SERVICE BULLETIN

M-1002

SAFETY RECALL CODE 072 1991 XLH RIGHT FOOTREST MOUNT

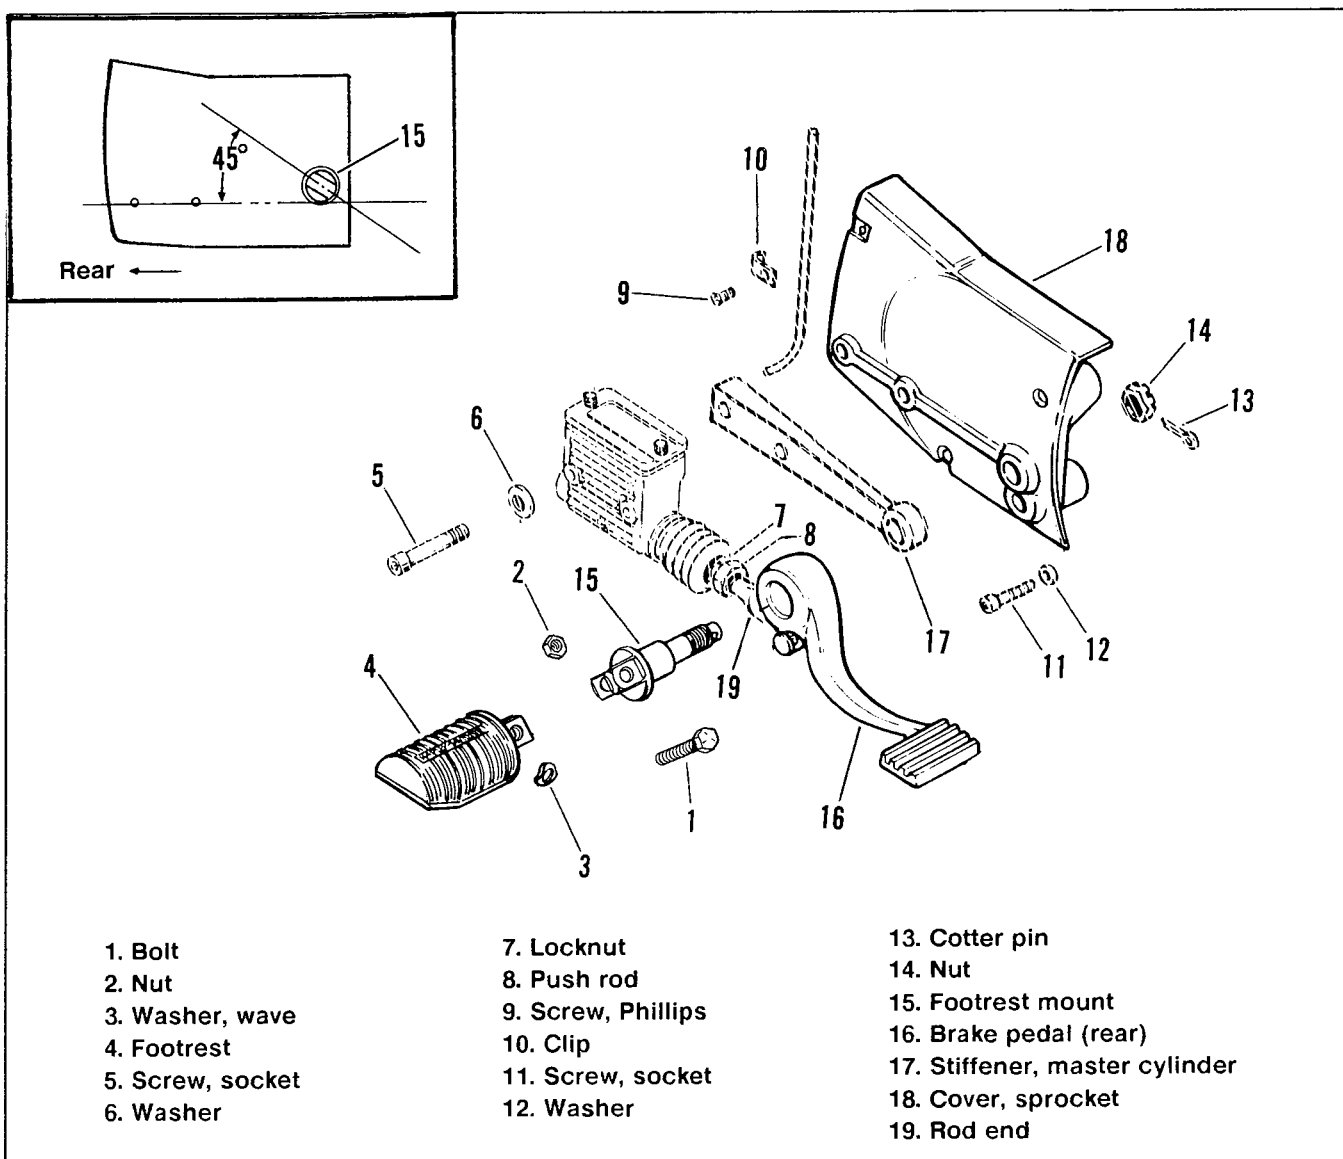
Harley-Davidson has become aware the possibility exists that the right side rider footrest mount could fracture if subjected to heavy impact loads. The fracture could result in reduced operator control. However, the rear brake system remains functional even without the right side footrest.

As a precautionary measure, Harley-Davidson recently elected to initiate a voluntary recall campaign in the interest of motor vehicle safety. The potential problem will be remedied by replacing the right side rider footrest mounting bracket on the potentially affected motorcycles.

1. See Figure 1. Remove bolt (1), nut (2) wave washer (3) with footrest (4). Discard bolt, nut and wave washer.
2. Remove the two socket head screws (5) and washers (6) attaching master cylinder to sprocket cover (18).
3. At rear brake linkage, back-off on locknut (7) and turn push rod (8) at flats until rod end (19) is free of push rod.
4. See Figure 2. Loosen hose clamps at heat shields (3) and (4). Position shields to gain access to cylinder stud nuts (1).
5. With extension and flex socket, remove the cylinder stud nuts (1) and washers (2).
6. Remove locknut (5) attaching front muffler to sprocket cover stud.
7. Remove bolt (6) and nut (7) attaching rear muffler to muffler support (8).
8. Remove exhaust system with heat shields as an assembly.
9. See Figure 1. Remove Phillips screw (9) and clip (10) attaching brake line to sprocket cover.

10. Remove the three socket head screws (11) and washers (12) attaching sprocket cover (18) to case. Remove sprocket cover (18) with footrest mount (15).

11. At backside of sprocket cover, remove cotter pin (13) and nut (14) from footrest mount (15). Discard nut and cotter pin. Keep footrest mount for return.

12. Insert new footrest mount (15) from kit through brake pedal (16), master cylinder stiffener (17) and sprocket cover (18). Thread on new nut (14) from kit. Refer to inset Figure 1. Orientate footrest to rear of vehicle at 45° and torque nut (14) to 40-50 ft-lbs. Insert new cotter pin (13), from kit, through mount and bend ends.

13. Hold cover (18) with mount in place and install three mounting screws (11) with washers (12). Tighten screws (11) to 90-110 in-lbs torque.
14. Attach brake line to sprocket cover with clip (10) and Phillips screw (9).

19. See Figure (1). Turn push rod (19) onto rod end (8) until foot pedal is nearly horizontal.
20. Place lockwashers (6) on master cylinder mounting screws (5). Insert screws through master cylinder, master cylinder stiffener (17) and thread into tapped holes in sprocket cover (18). Tighten mounting screws (5) to 155-190 in-lbs torque.

Figure 2. Exhaust System

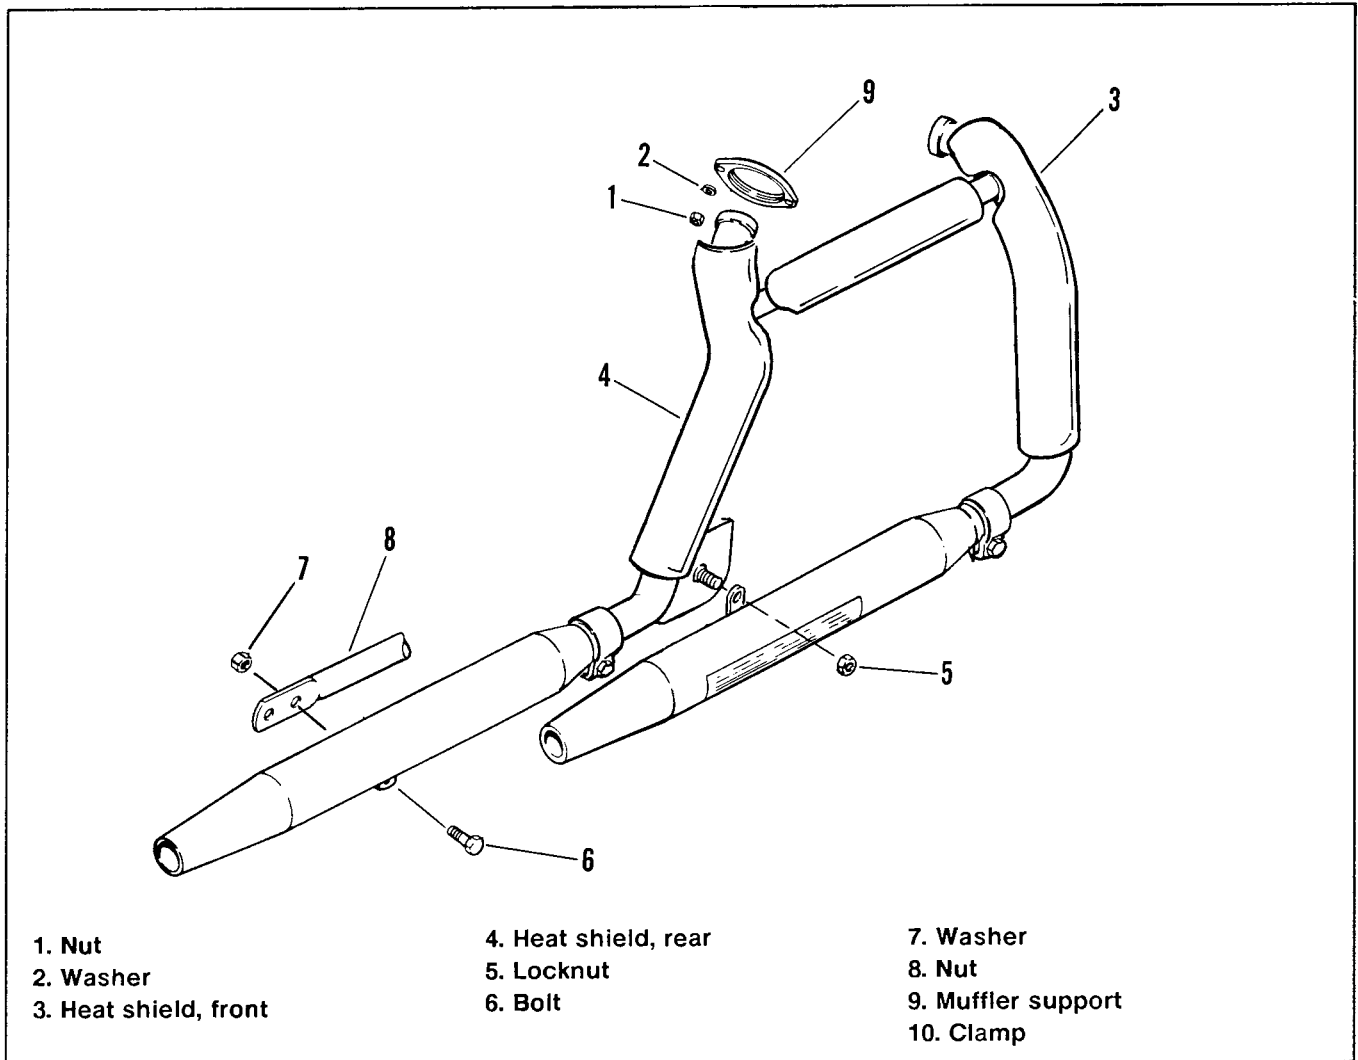
15. See Figure 2. Place exhaust system in position with clamp rings (9) over studs in cylinder heads and front muffler tab over stud in sprocket cover.

16. Place washers (2) over cylinder studs and thread on nuts (1). Tighten nuts (1) to 60-80 in-lbs torque, using extension and flex socket.
17. Install nut (5) on sprocket cover stud and tighten to 50-60 ft-lbs torque.

18. Insert bolt (6) through rear muffler tab and hole in muffler support (9). Place lockwasher (7) on bolt (6) and thread on nut (8). Tighten nut (8) to 19 ft-lbs torque.
